Gallery Road Raised Zebra Crossing

Consultation Summary

December 2014

Appendix A Initial Scheme Design

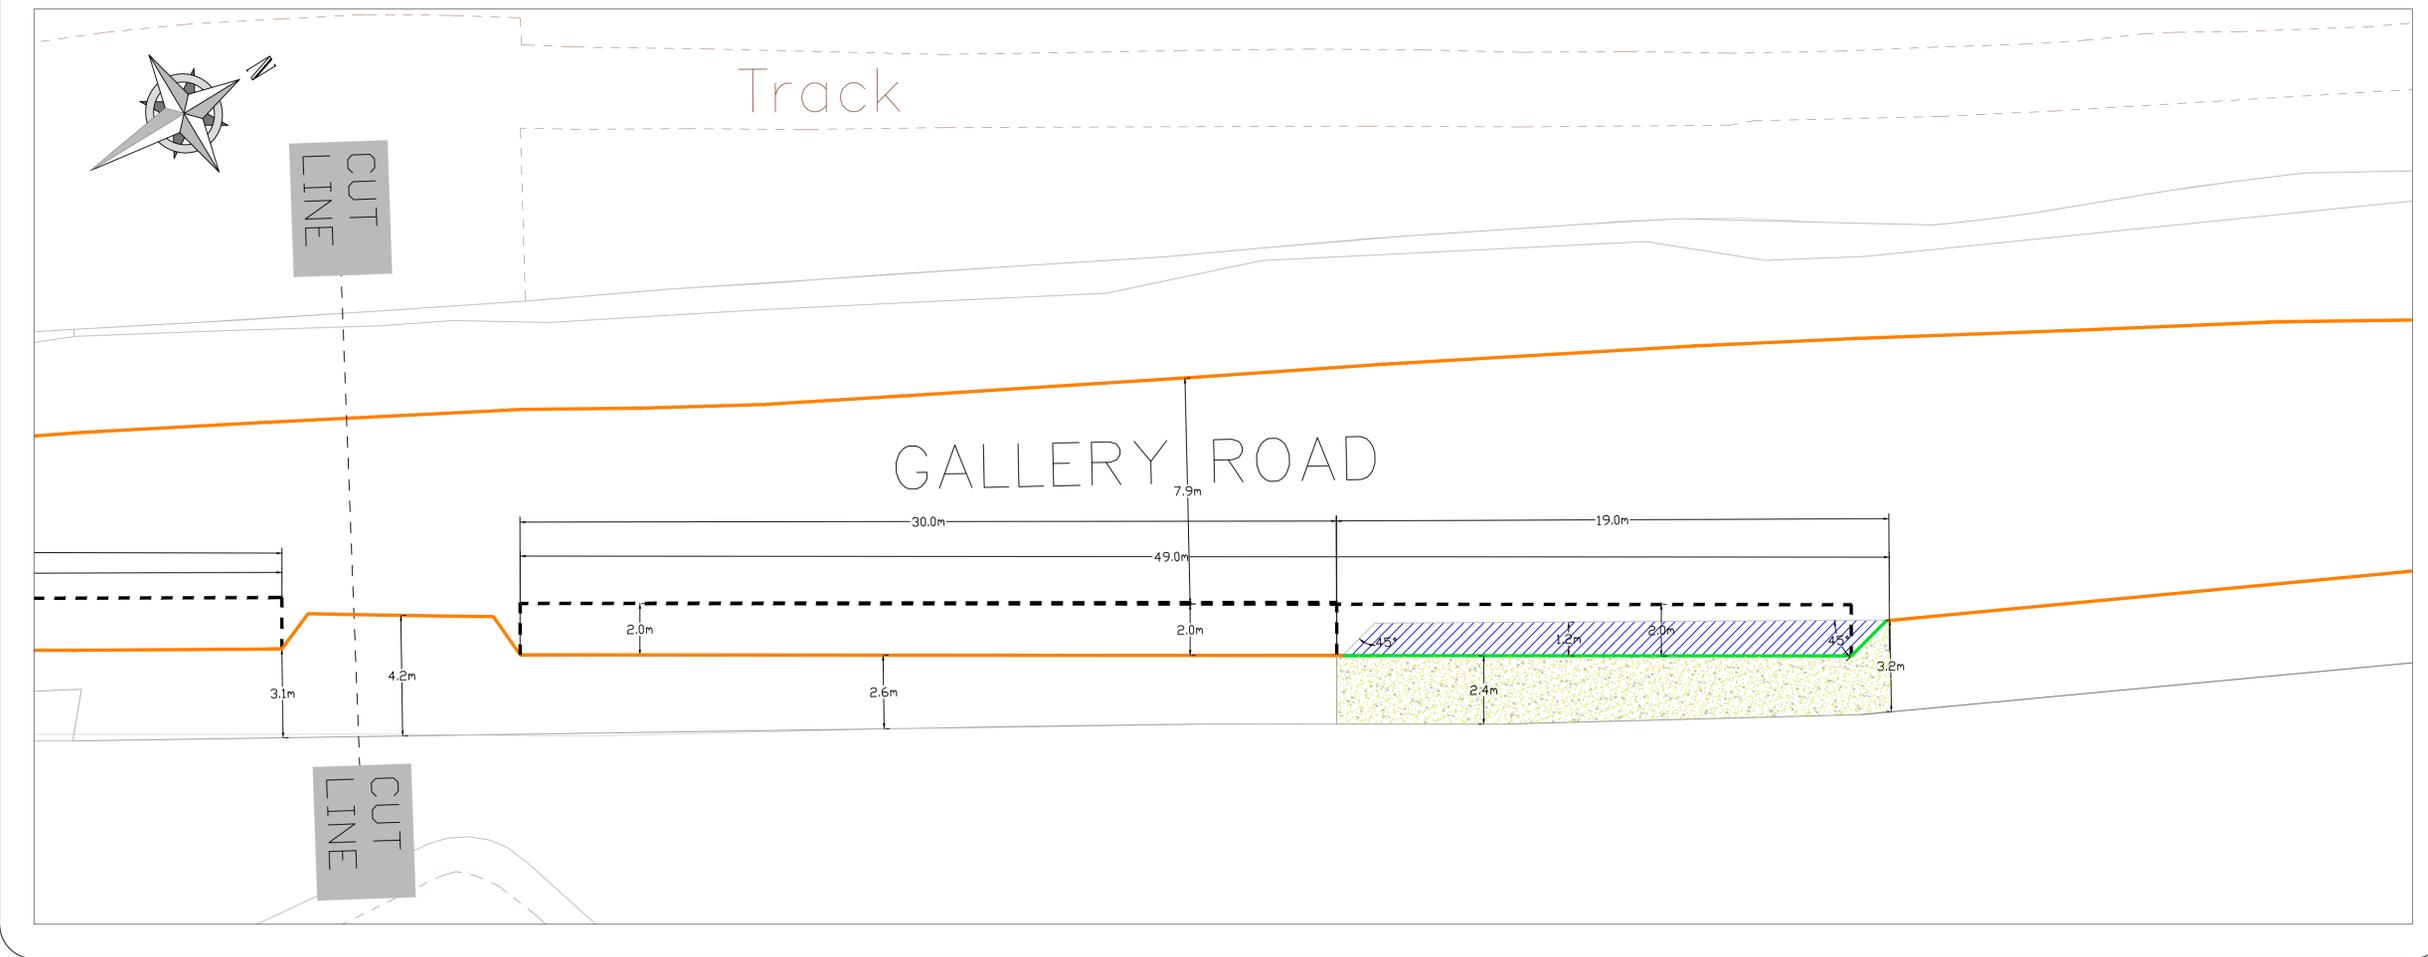
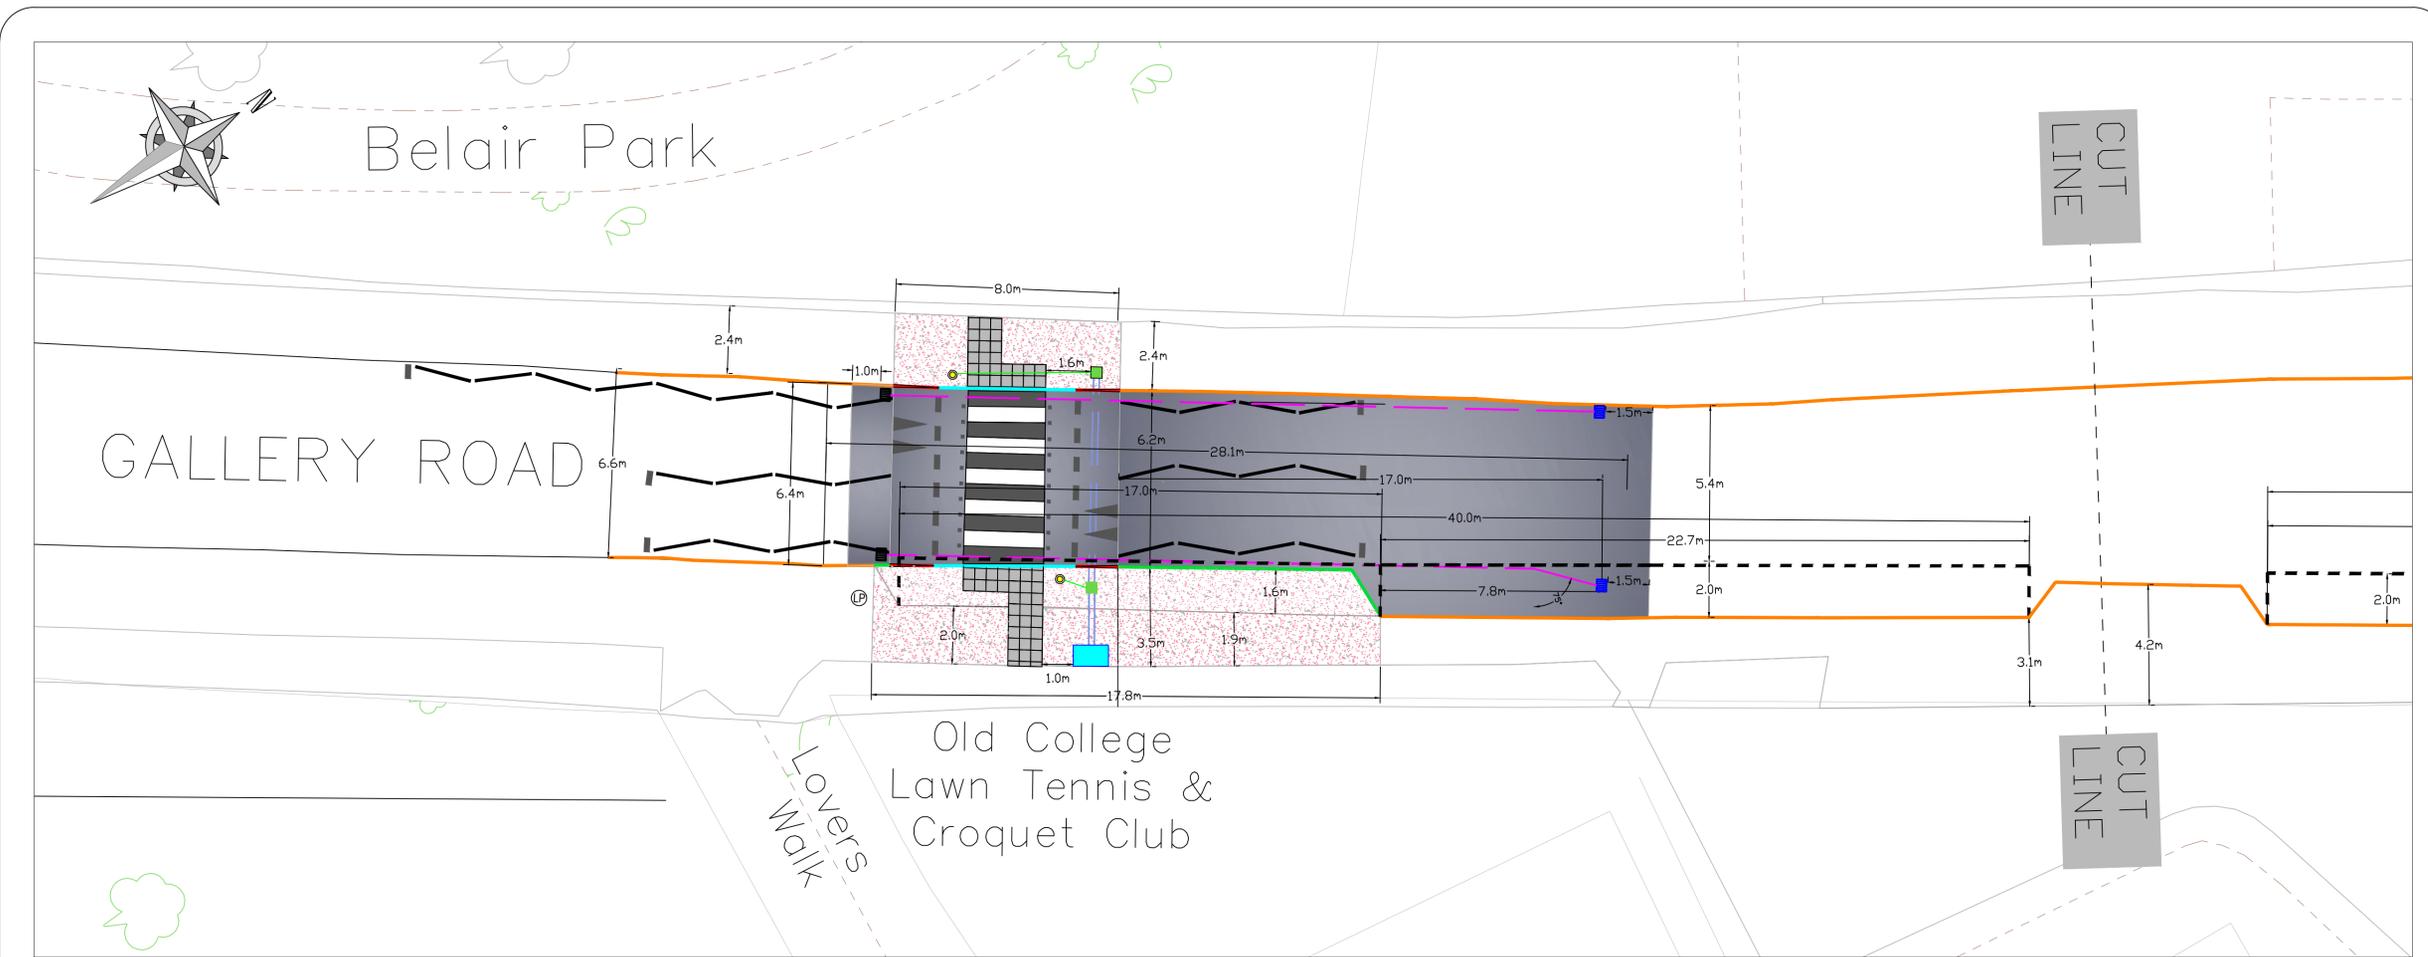
'Thank you very much for consulting Old College LT&CC on the proposed crossing on Gallery Road between Lover's Walk and Belair Park. We have considered this and consulted our members. Our two prime concerns are safety, which the crossing will improve, and maintaining the parking spaces available in the two bays adjacent to the Club's grounds. The proposal you make, to reduce the southerly one but to lengthen the northerly one, addresses this concern. Needless to say we would be very concerned if this were to be abandoned, but we trust that will not happen. So, subject to that, we are very content with your proposals.'

- b) A representative from **Southwark Cyclists** replied expressing concern at the proposed footway buildout on the eastern side of the crossing, highlighting that it may pose a danger to cyclists.

- c) The **Metropolitan Police Traffic Management Unit** replied indicating that traffic speeds on Gallery Road are quite high and that although the pedestrian crossing is being raised, which will help with reducing speeds, further consideration should be made to installing additional traffic calming measures either side of the crossing.

* In response, a full road safety audit has been carried out on the scheme design and no adverse safety issues were identified resulting from the kerblin extension and footway buildout. In addition, the footway buildout extends no further than the adjacent inset parking bay. The parking bay has a high occupancy rate associated with the adjacent tennis club, Belair Park and the Picture Gallery. Cyclists traversing past vehicles in the parking bay and on approach to the crossing location will not have to deviate from their line in order to negotiate the crossing facility.

* In response, Gallery Road is shortly to become part of the borough-wide 20mph limit. This initiative will assist with curtailing traffic speeds and improve safety for more vulnerable road users including pedestrians and cyclists. In addition, the scheme will be monitored following implementation to ensure that the design is sufficient to ensure the safe passage of pedestrians across Gallery Road.
